FW: O8W-PM [Redacted] - Bucks Creek 1101 Phase 1,2&3 -
Pre-Engineering Meeting

Subject: O8W-PM [REDACTED] - Bucks Creek 1101 Phase 1,2&3 - Pre-Engineering Meeting

Bucks Creek 1101- PM# [REDACTED] Overview Map

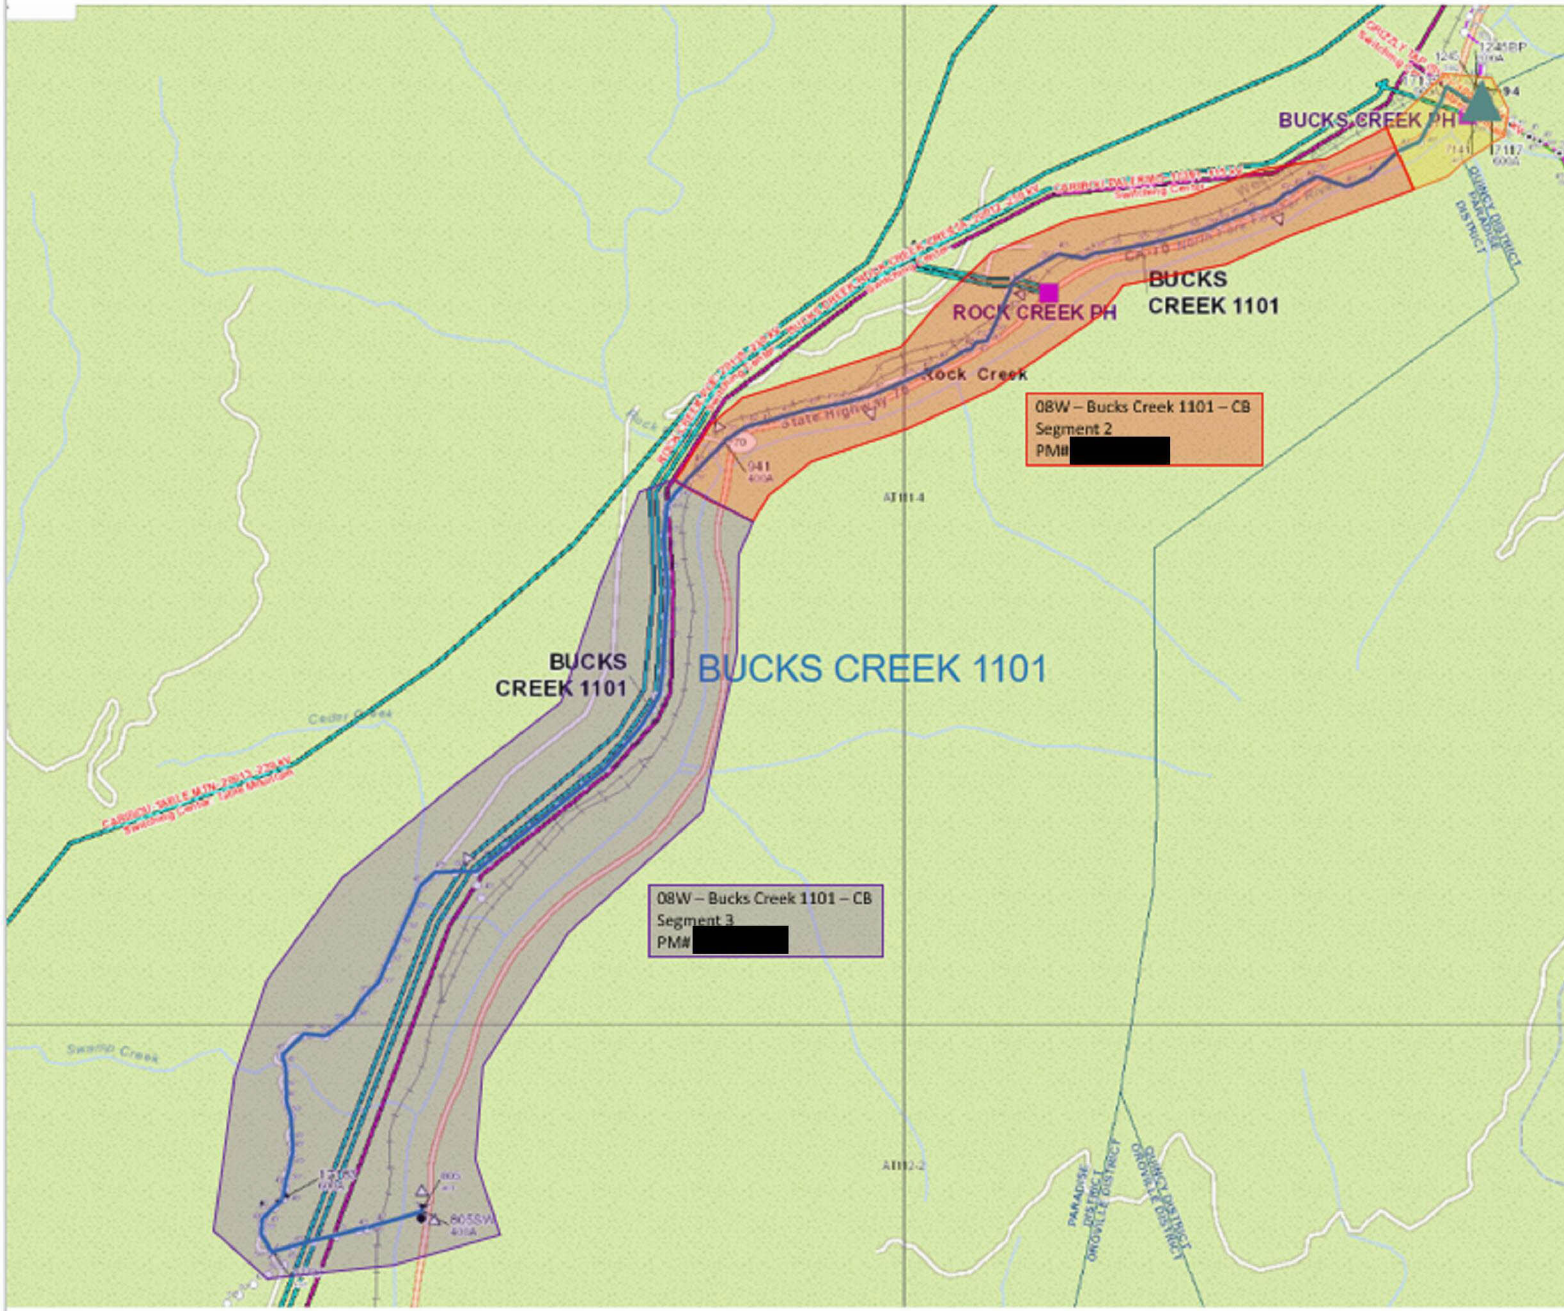
For Bucks Creek there is quite a bit of work surrounding Hwy 70 and we will need a Land Department Base Maps prepared for all 3 Orders. This will delay the EOD dates until these can be developed and provided to the Vendor... We will also need answers to the questions outlined by [Redacted] below...
